ADDENDUM NO. 2

NEW GYMNASIUM ADDITION TO MONTEVALLO HIGH SCHOOL

Architect Job No. 25-33

December 8, 2025

1 NON-PRESSURE PIPING - CONCESSION ENLARGED PLAN
3/8" = 1'-0"

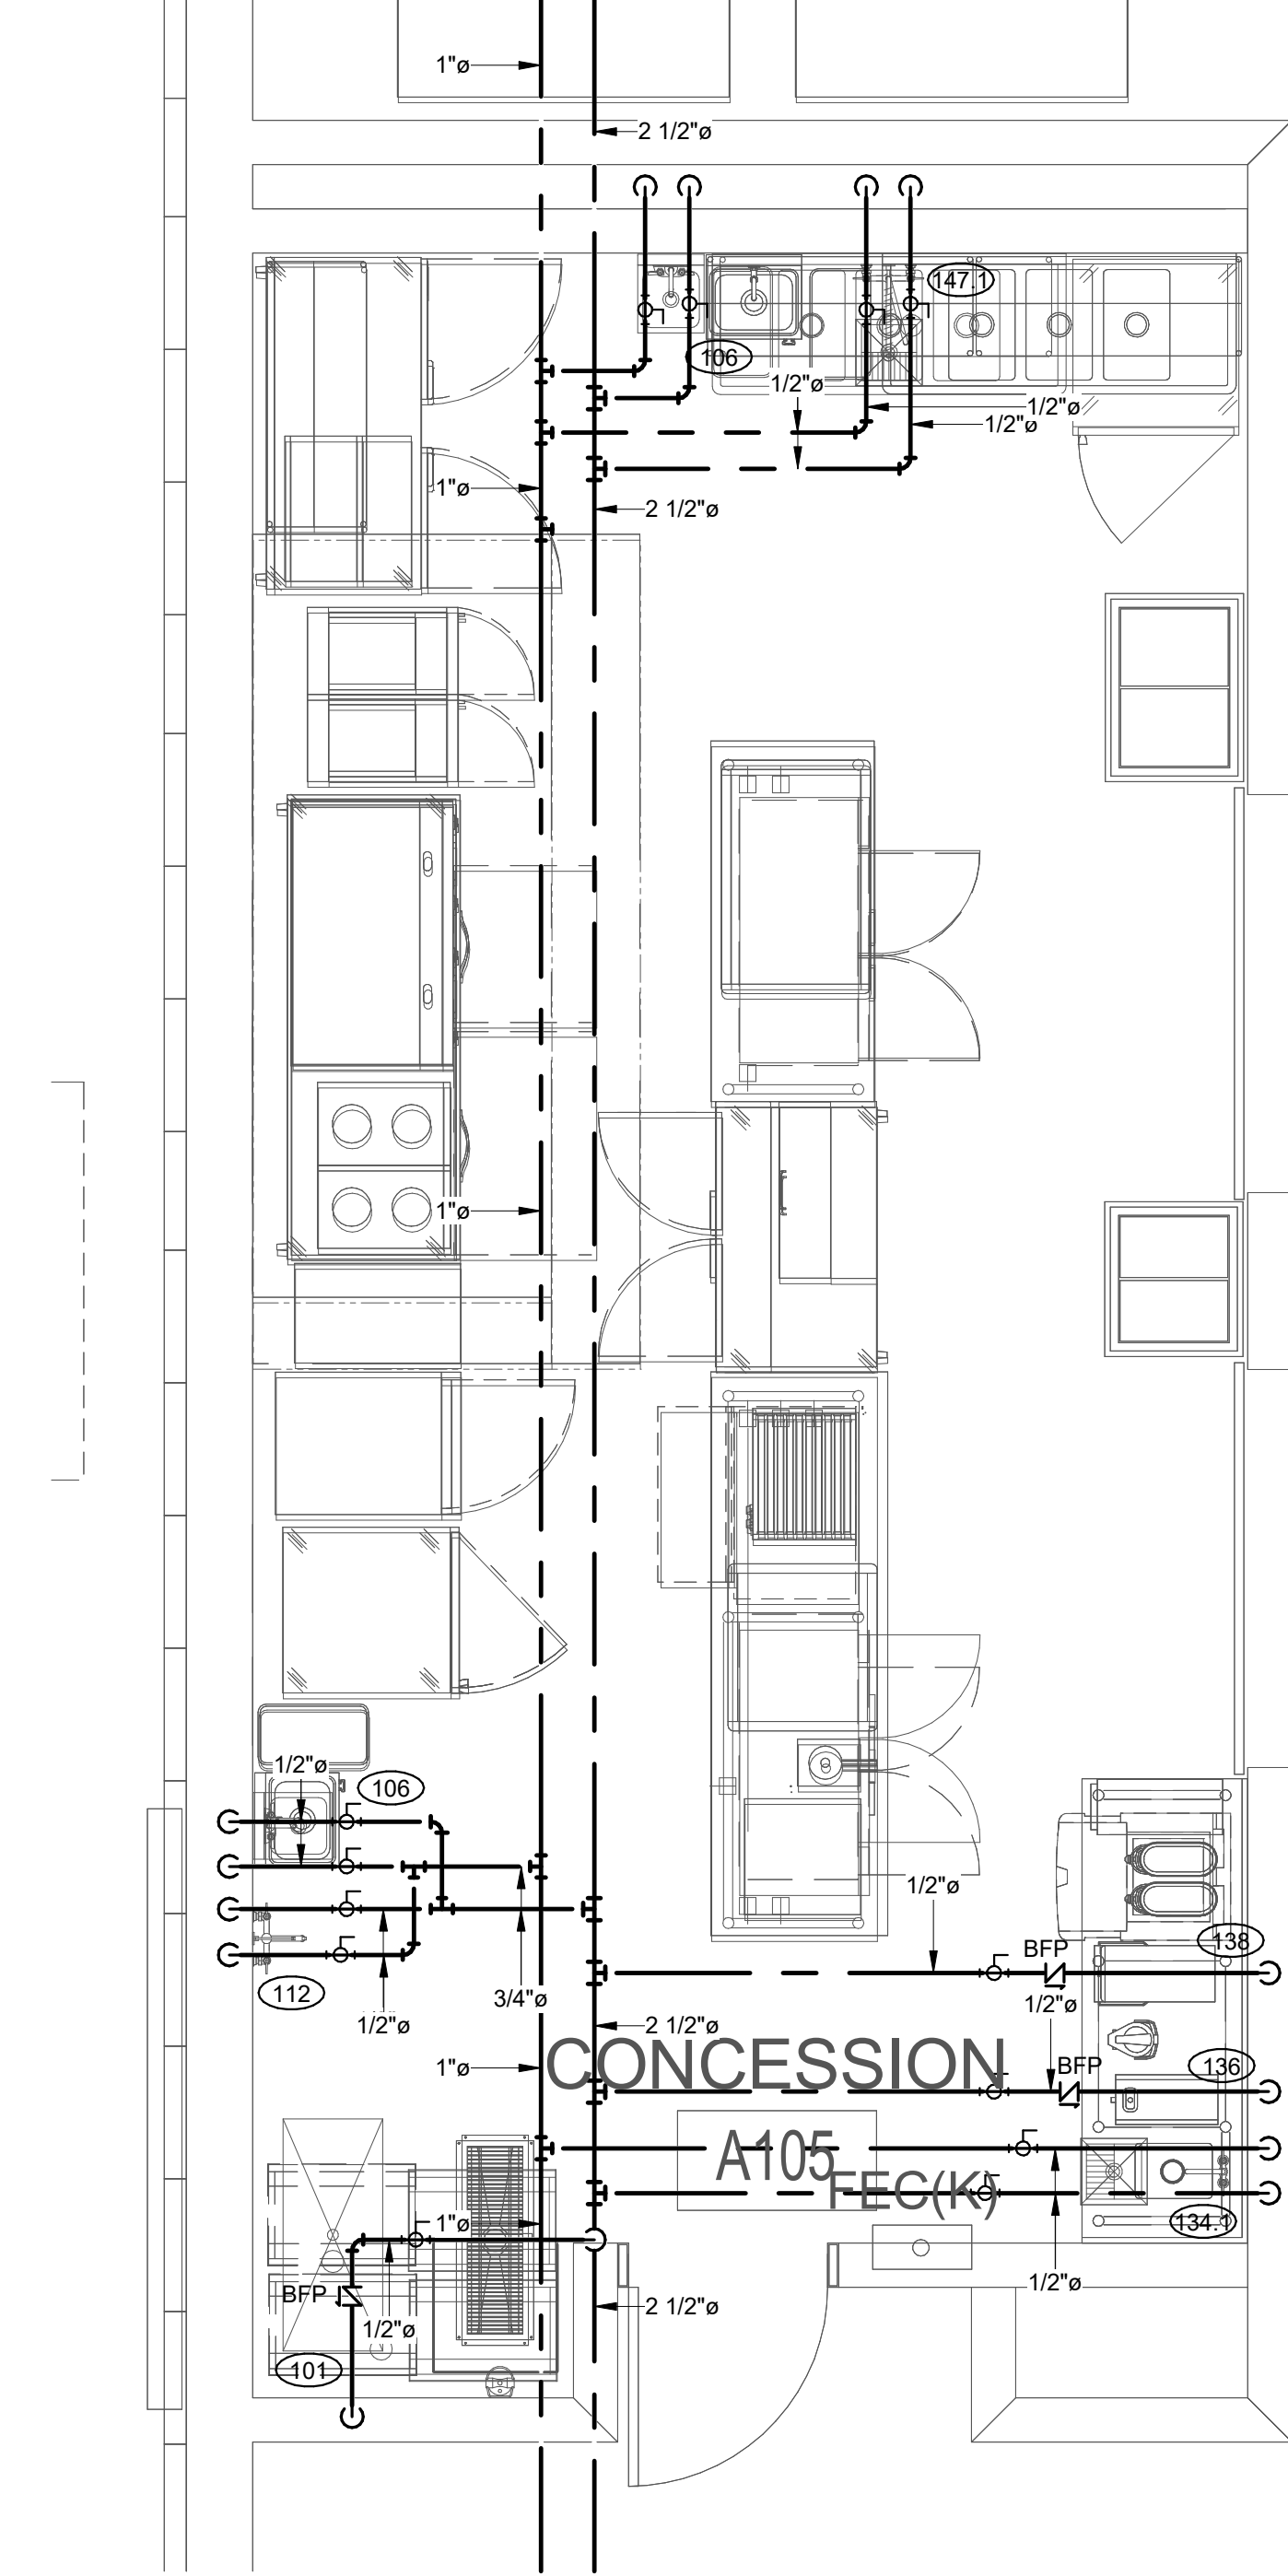
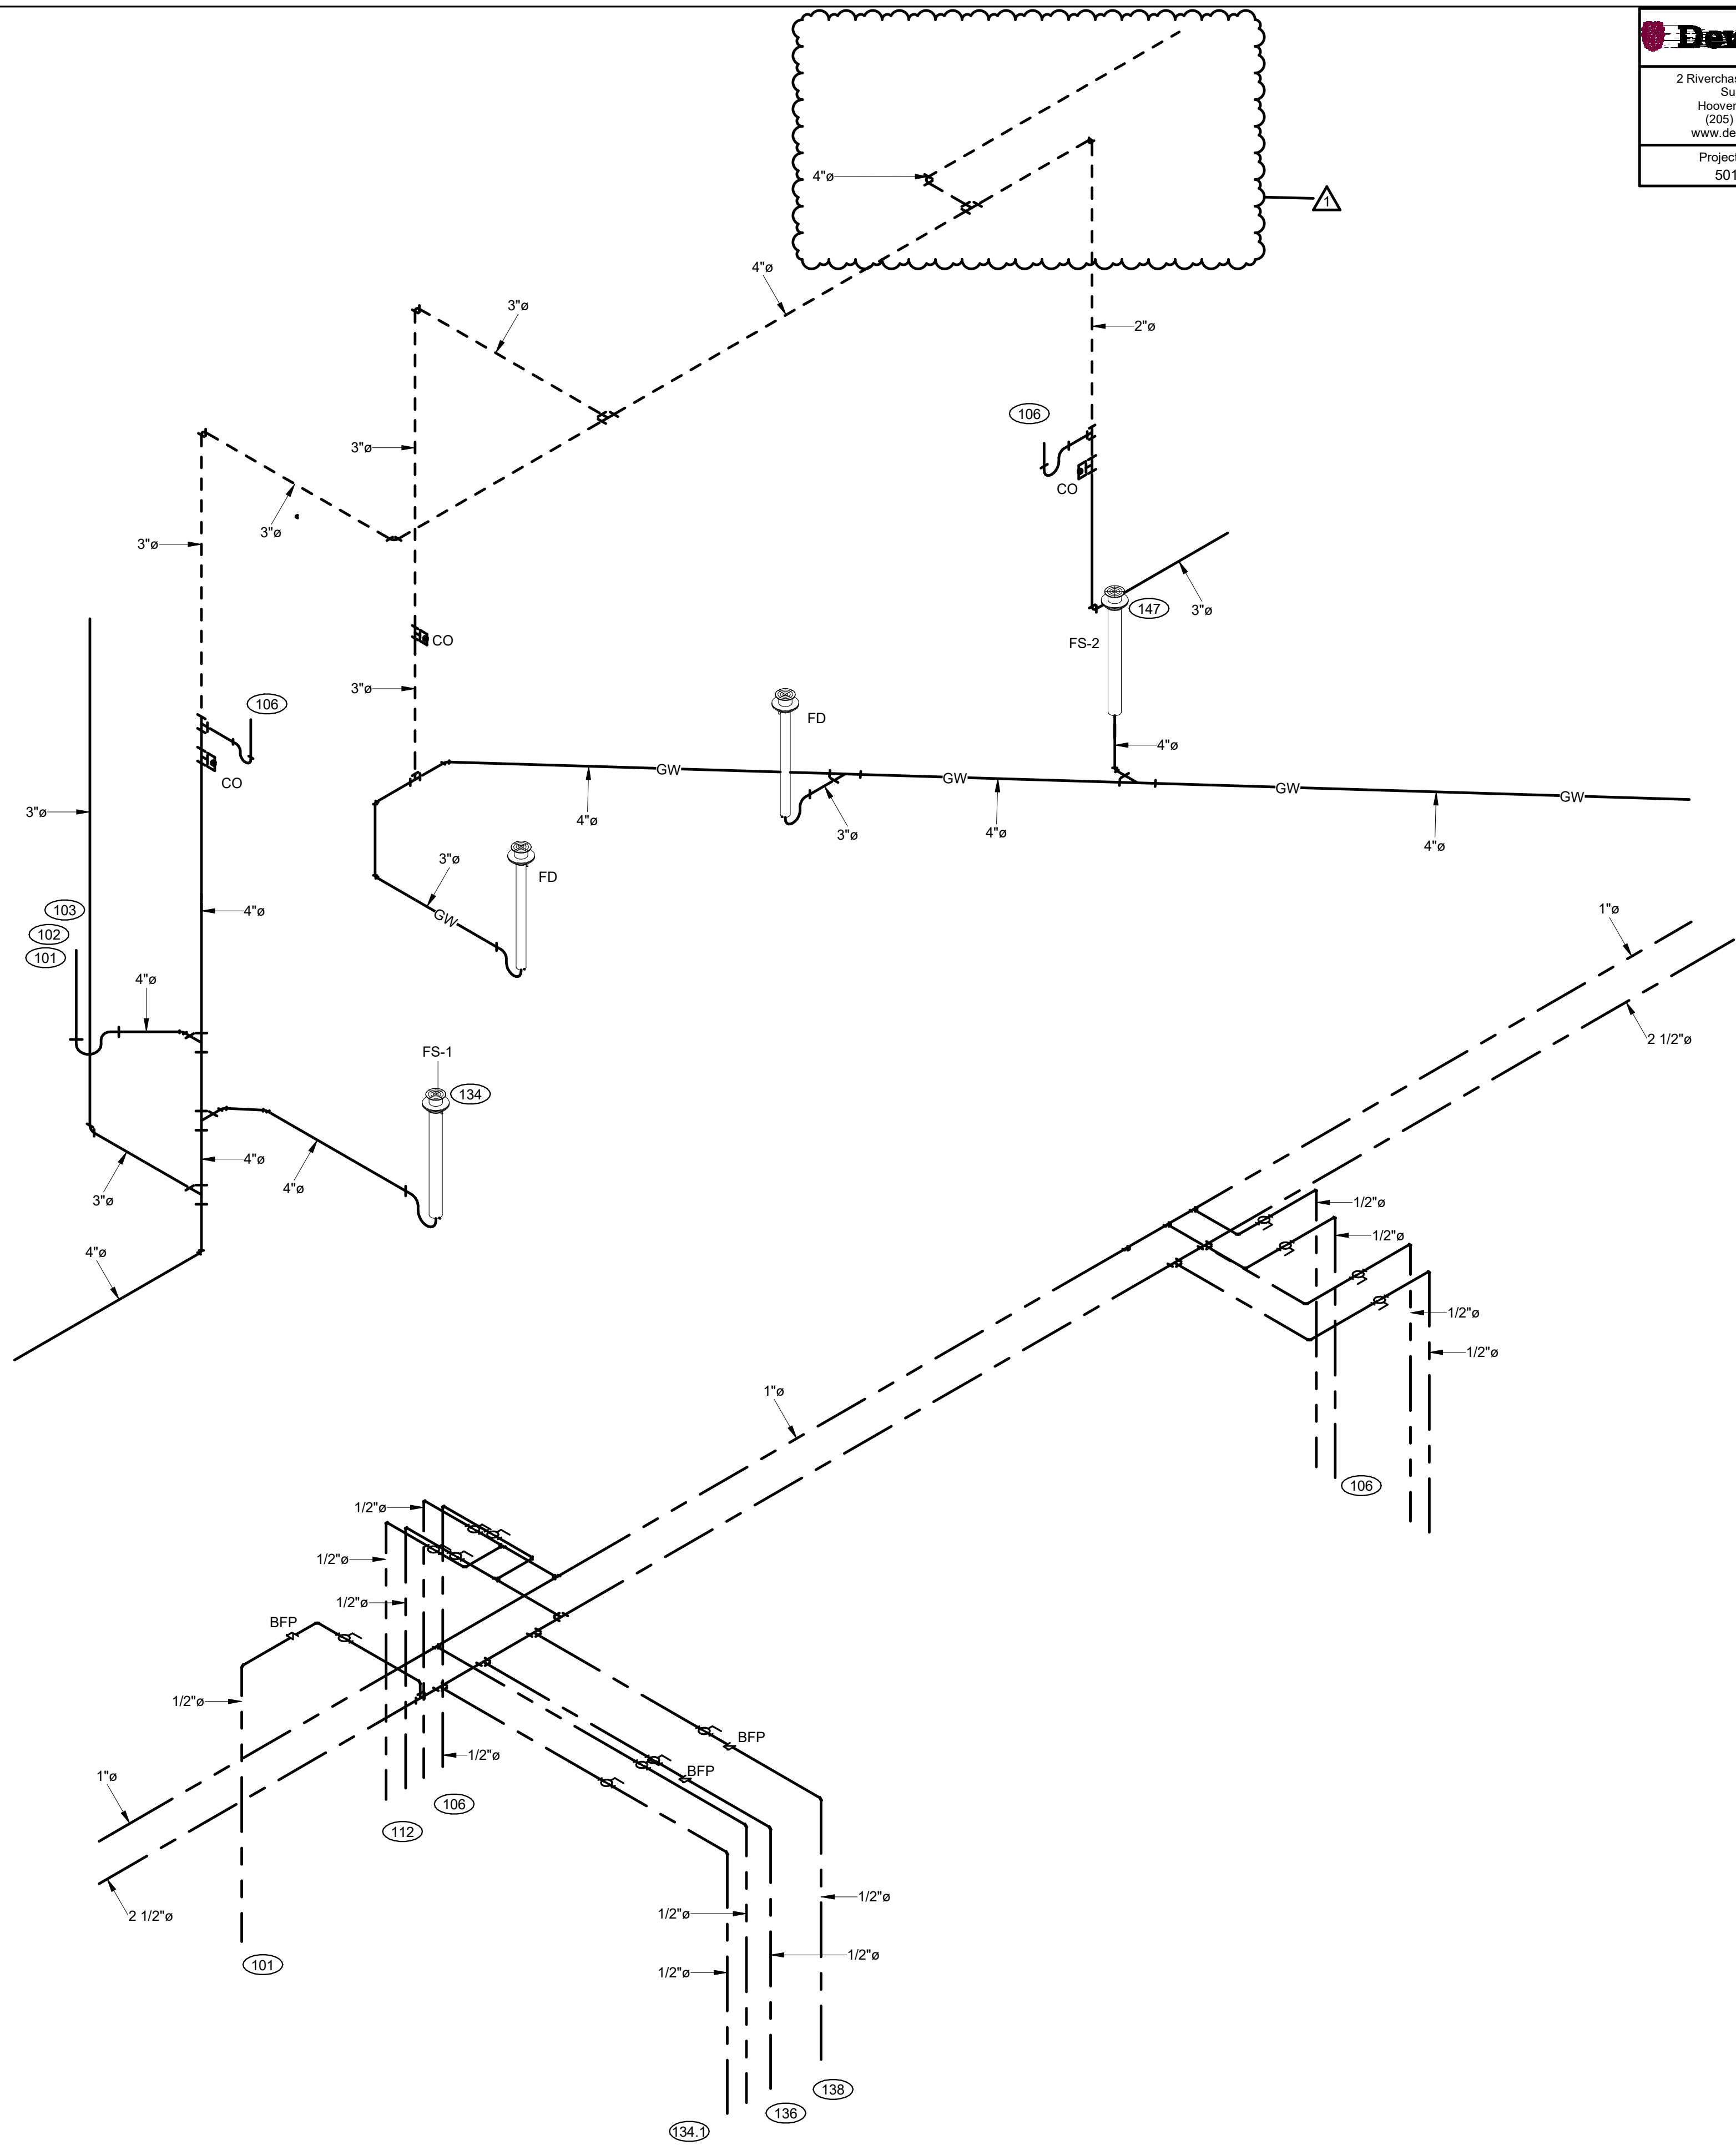
18. **Sheet P3.0** – Revised pipe sizes in Men A101.
19. **Sheet P4.0** – Revised vent piping.
20. **Sheet P5.0** – Revised vent piping and piping sizes.

21. **Sheet P5.0** – Revised waste riser accordingly.

16. Both Handsinks shown on P5.0 Food Service Equipment Schedule shall be provided by KEC.

**1** **MECHANICAL - FLOOR PLAN**
1/8" = 1'-0"
0' 4' 8' 16'
SCALE: 1/8" = 1' - 0"

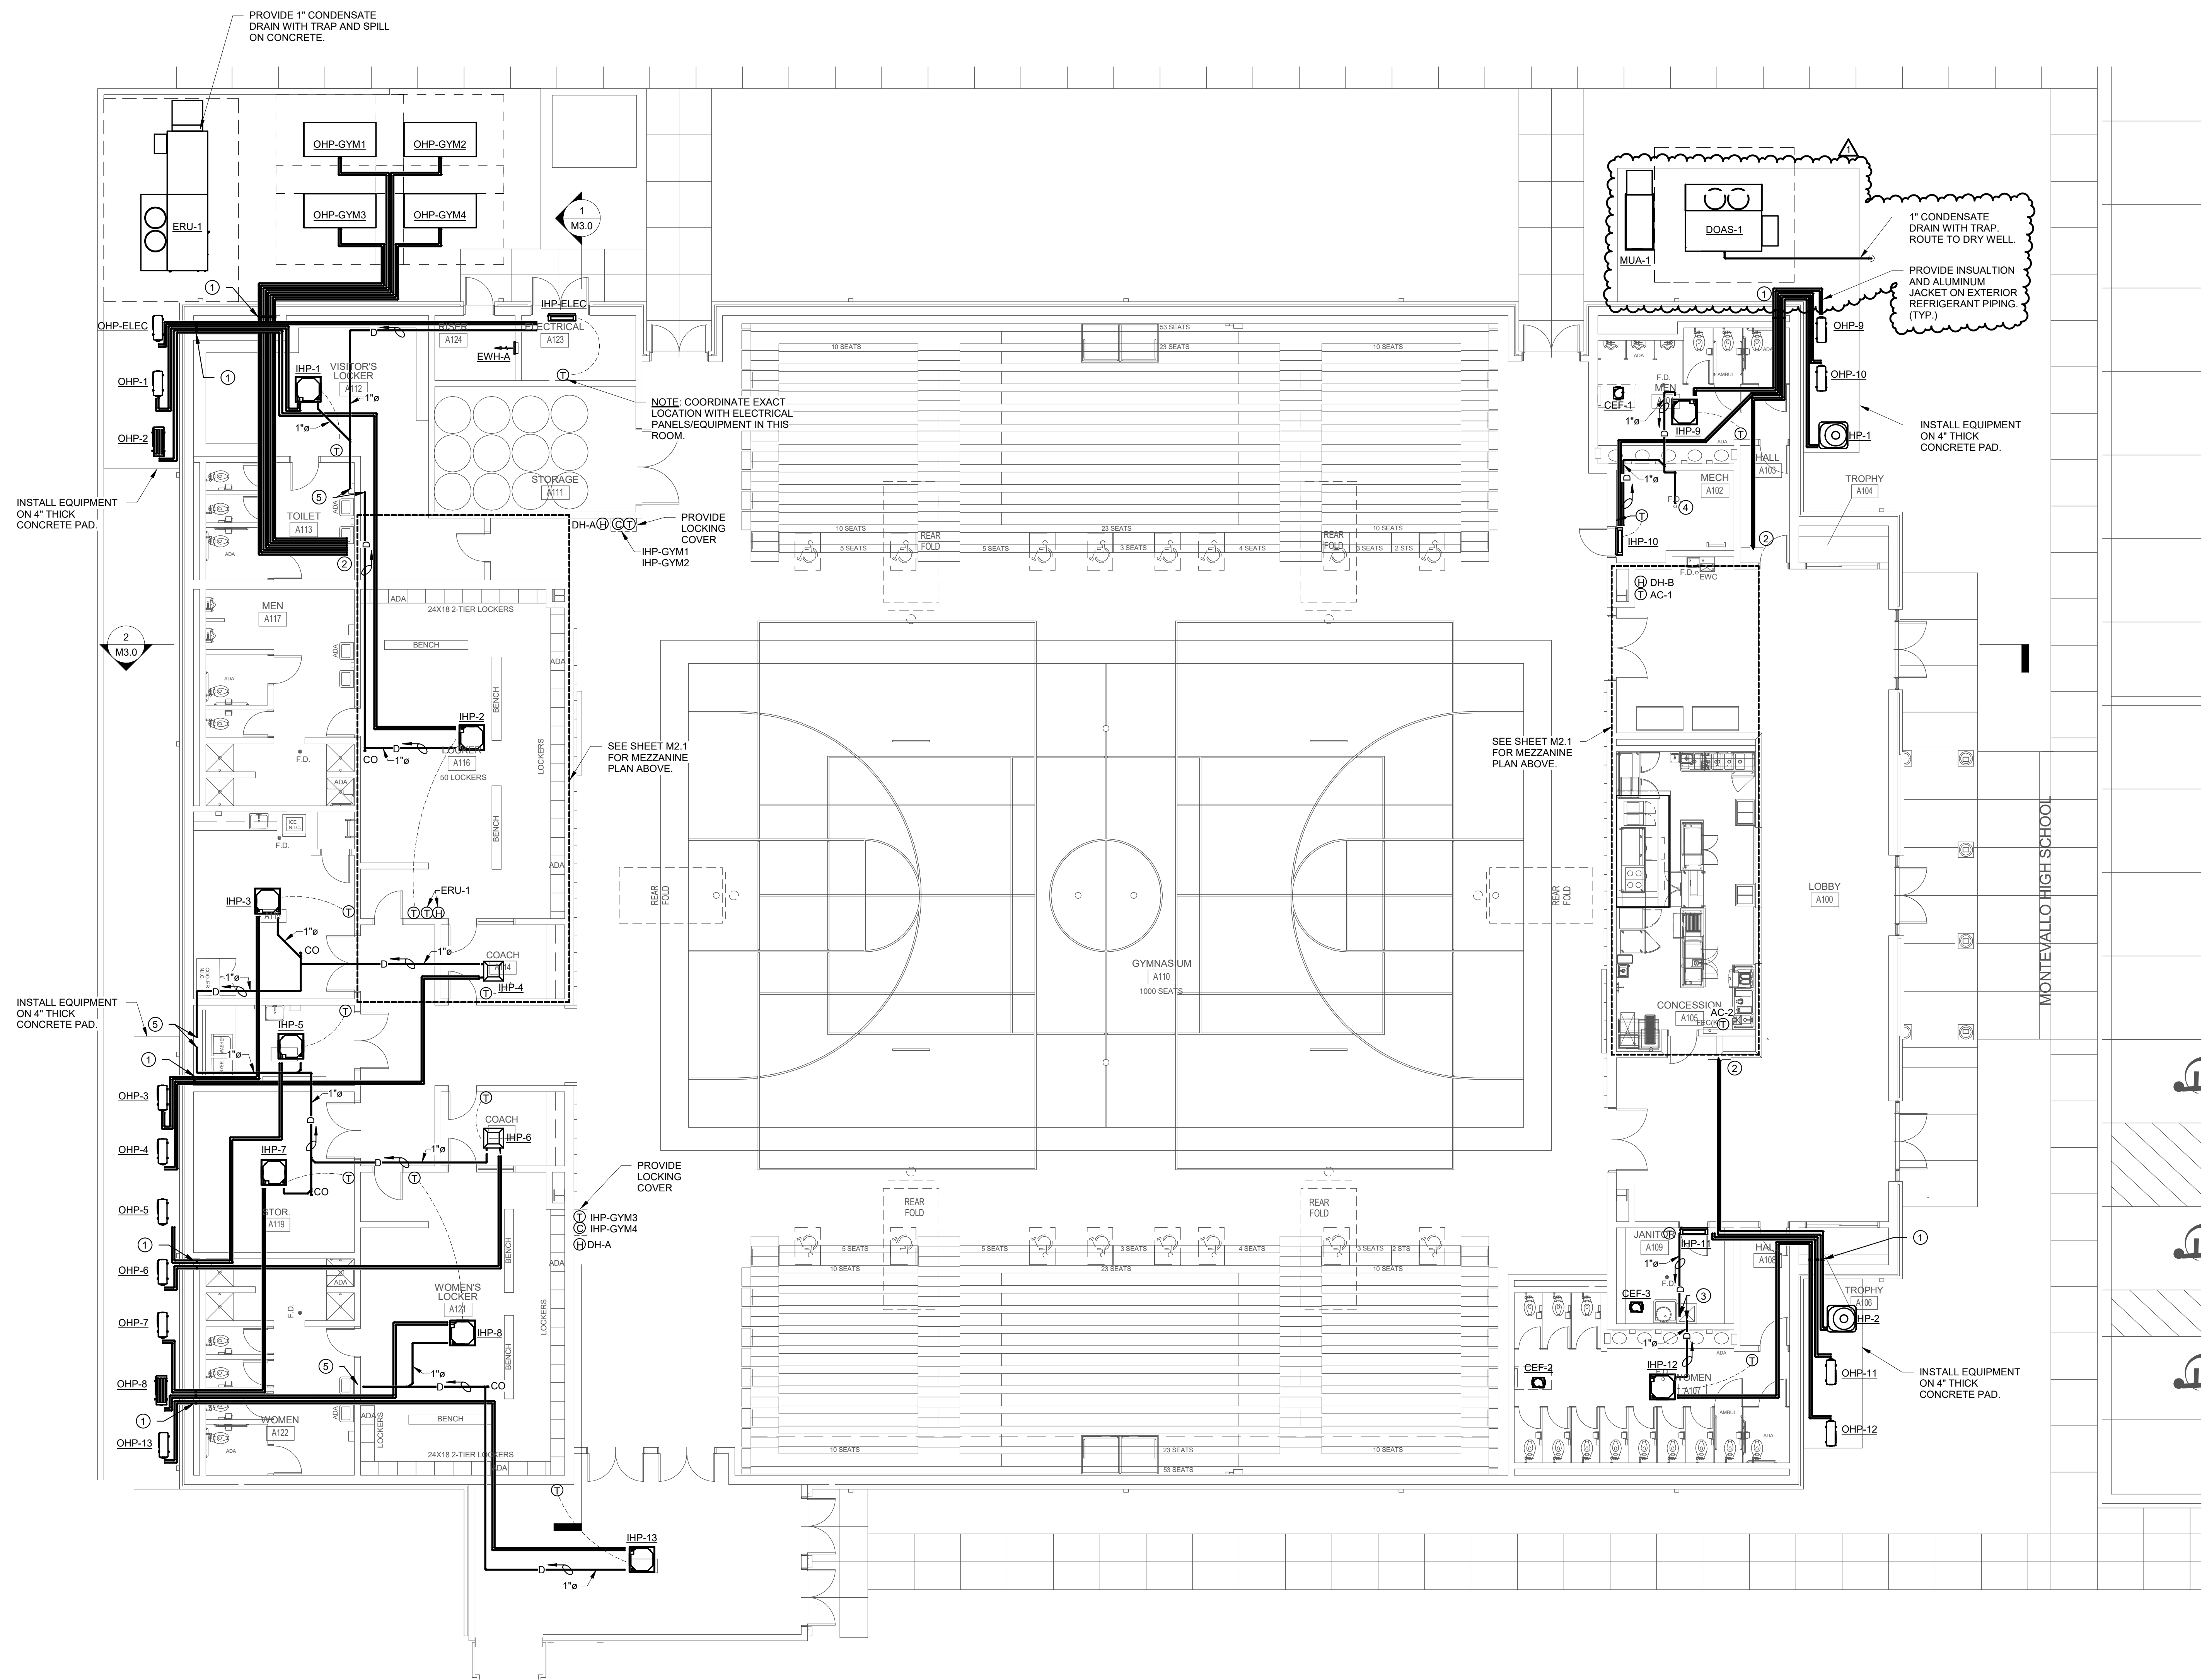
6. **Sheet M1.0** – Added keyed note 5, showed access door locations in grease duct. Removed section of 12x12 ductwork near Women A107 that is not required. Revised note about dryer exhaust. Adjusted size of concrete pad for DOAS-1 and MUA-1 to align with Architectural & Civil.
